STAFF REPORT

APPLICATION CSPA 84-D-049-03

PROPOSAL: Amend the approved comprehensive sign plan for the Tysons Galleria to permit replacement of existing monument, garage, and mall entrance signs, as well as provide two new monument signs.

M3 LARGE MONUMENT 16'-0" (W) X 5'-4 1/4" (h)
1/2" = 1'-0"

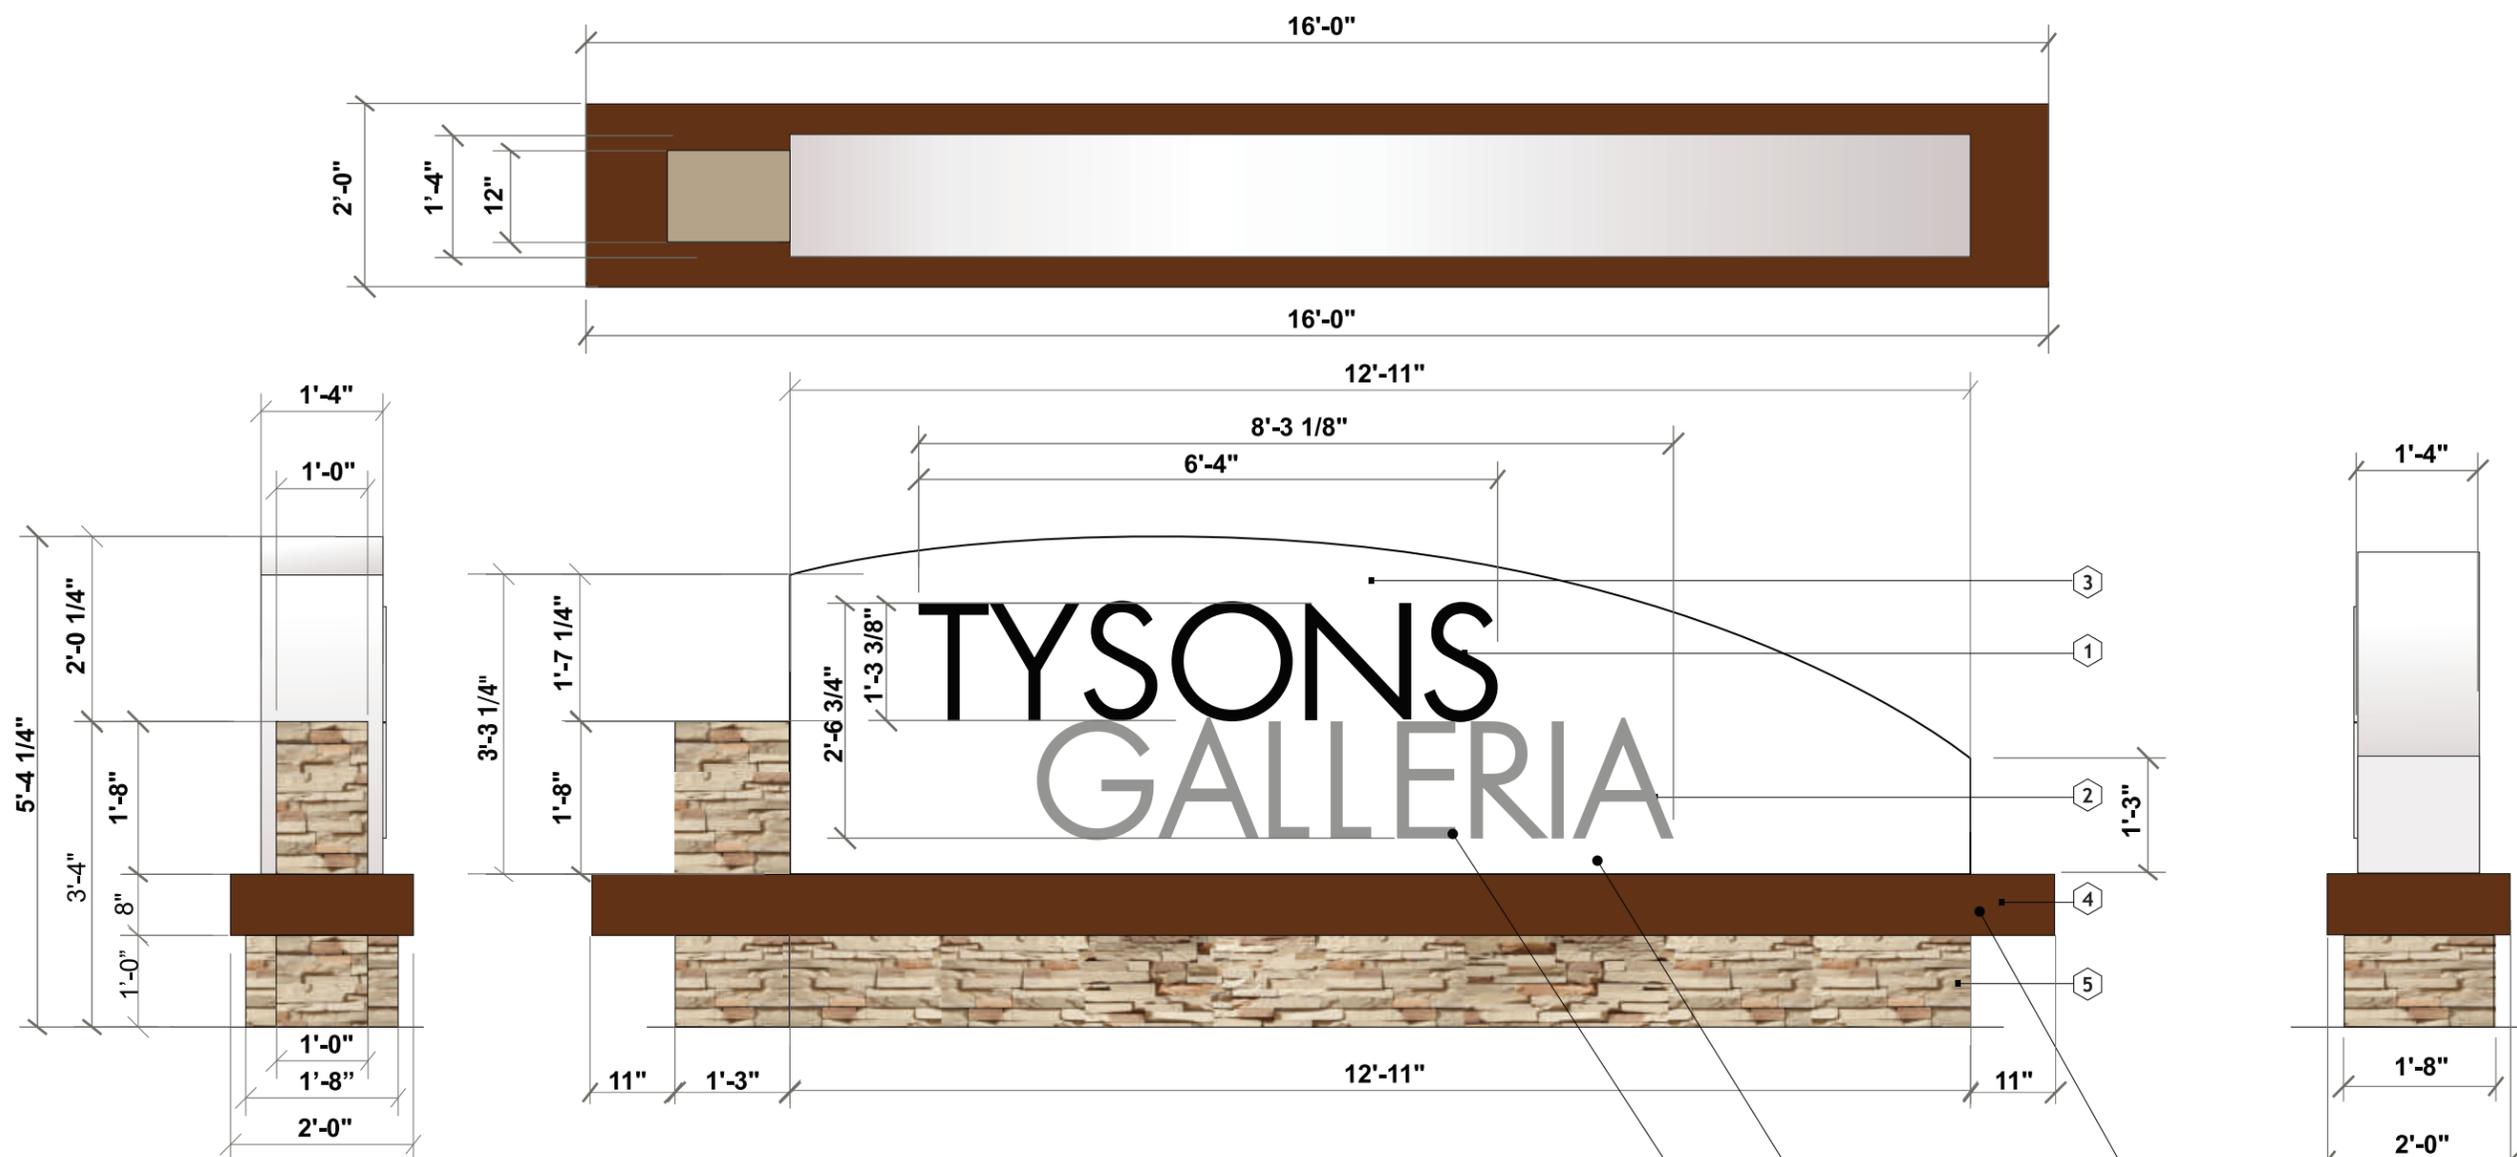
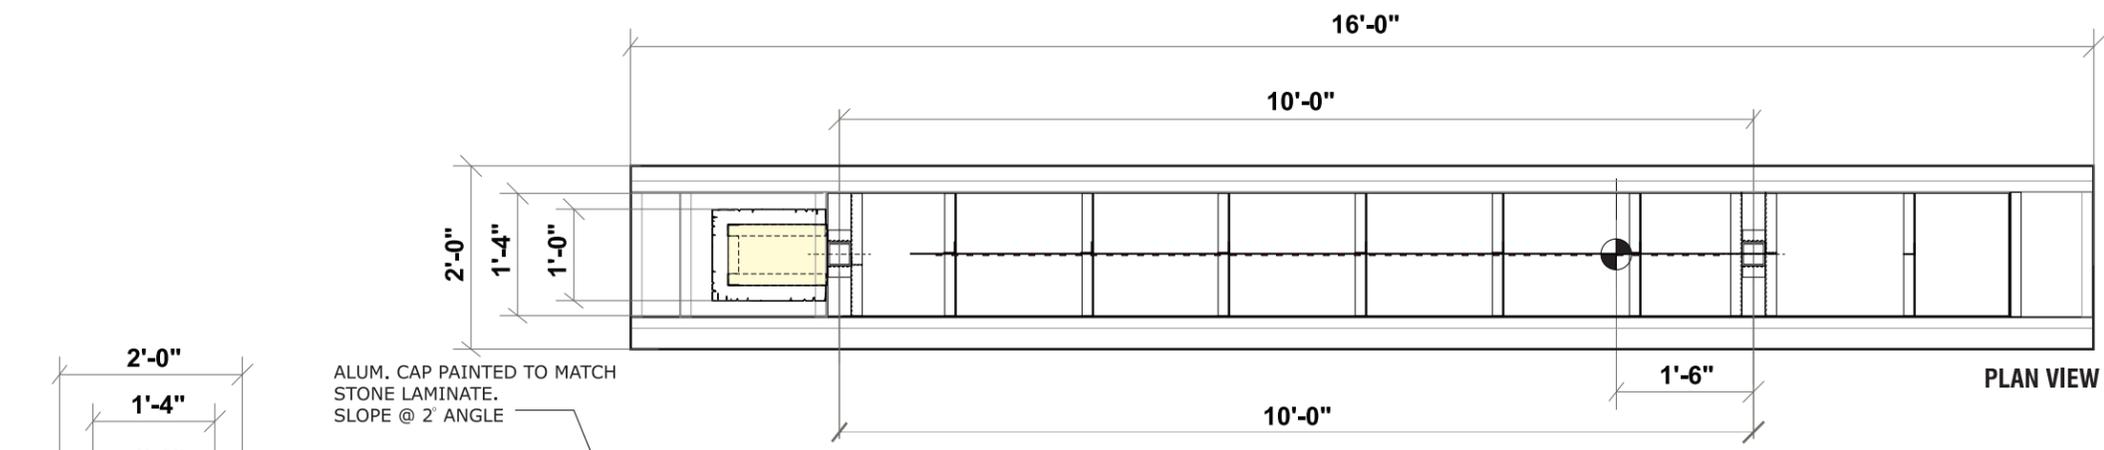
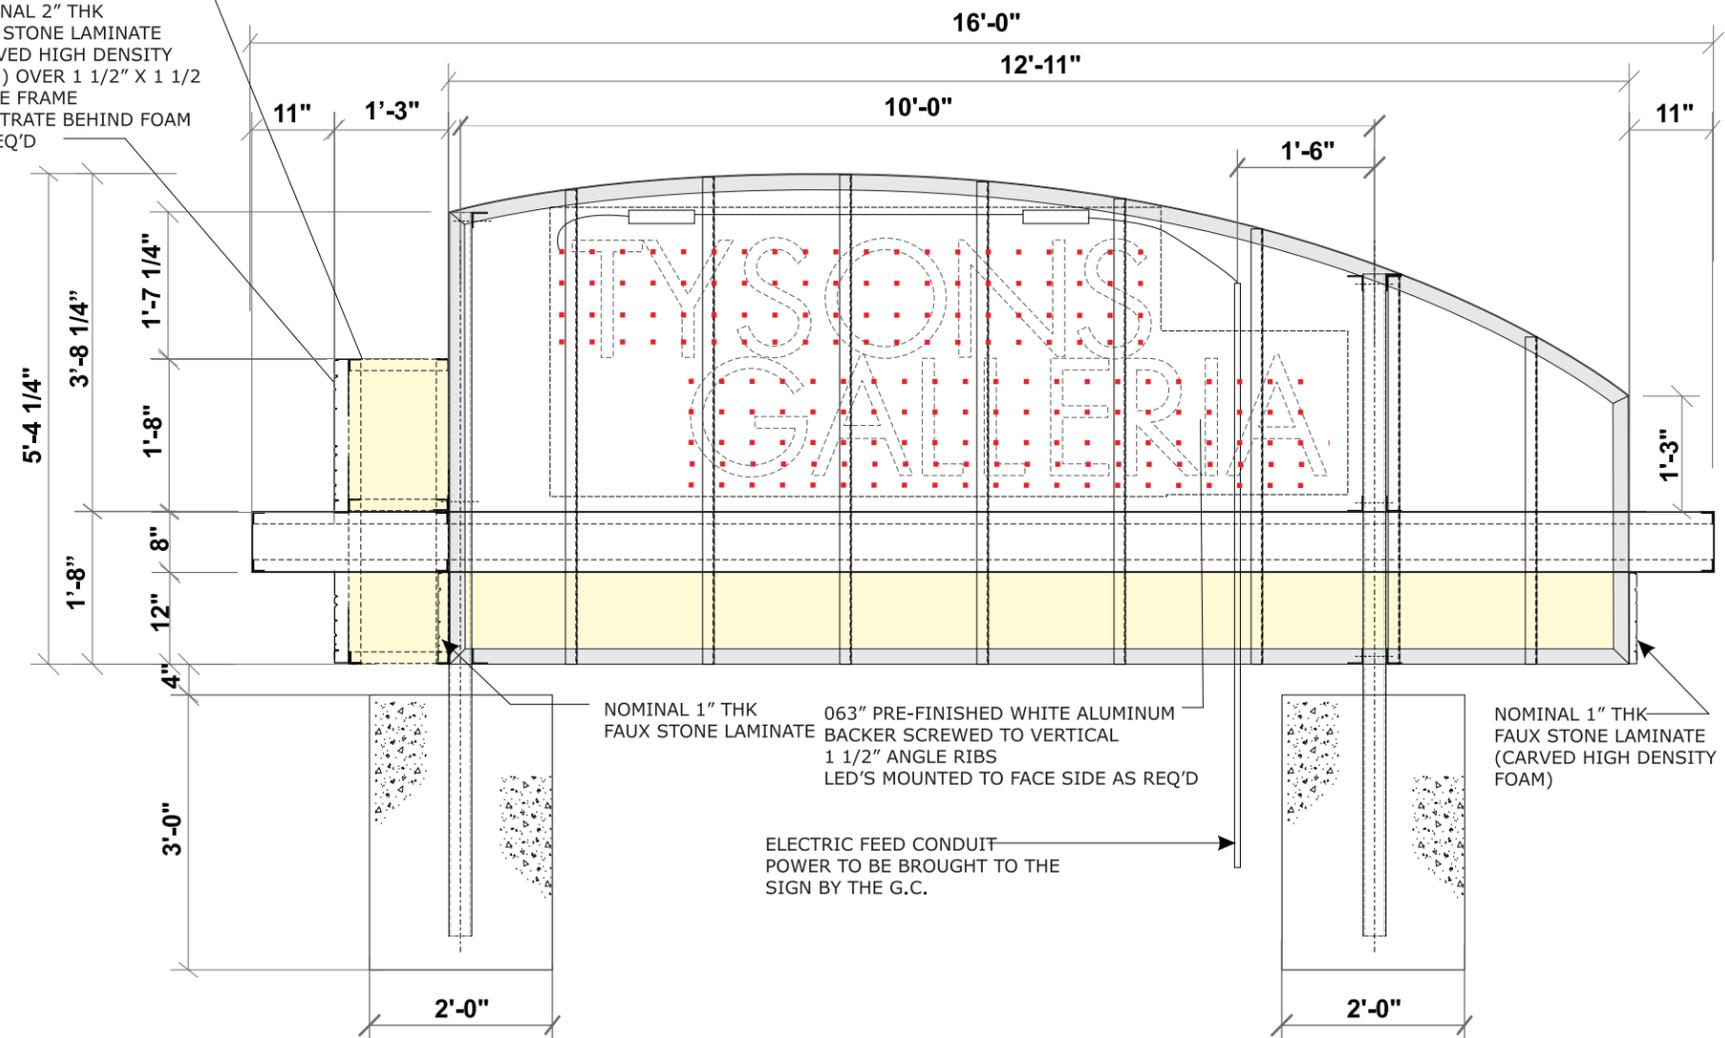
2. The CSPA, titled "Tysons Galleria – Proposed Exterior Sign Updates", prepared by Service Select, LLC, date stamped August 12, 2014, is approved for those signs shown on the CSPA, *excluding the monument sign identified as M3*. Modifications to tenant signs allowed by the CSP shall not include any increase in size or number above that shown on the CSP.

Sign Matrix

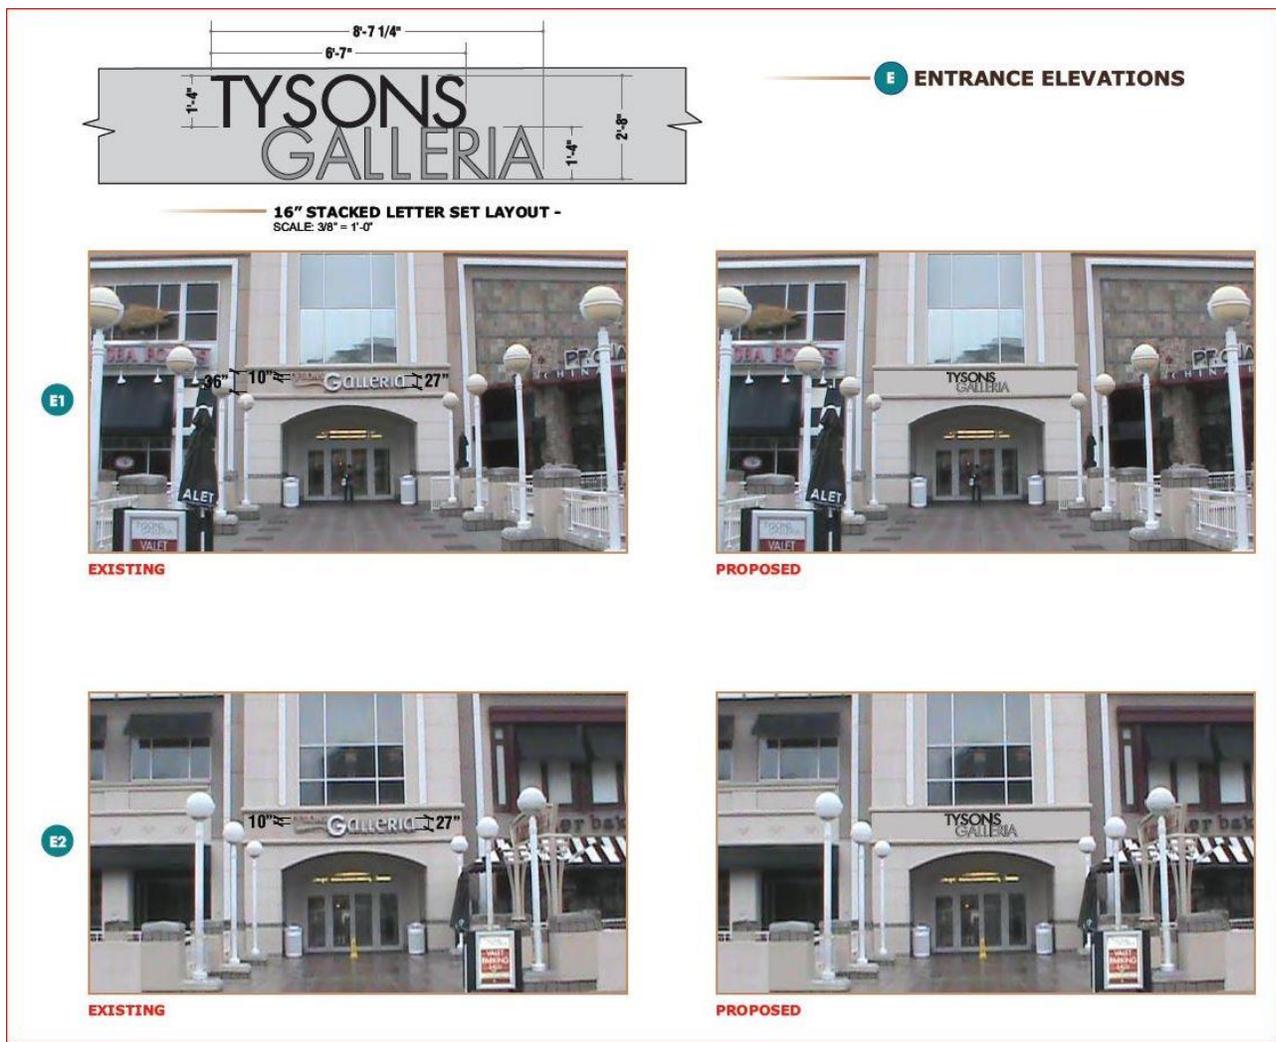
In addition to the comments above, the applicant should revise Sheet 16; the large format sheet submitted appears to be partially written with 'Wingdings' and is illegible. In addition, the applicant should include a matrix of signage including the maximum square feet of signage for the existing and proposed signs. While the signage size and locations are appropriate for this application, this information will be helpful in the event of future CSPA applications by this applicant.
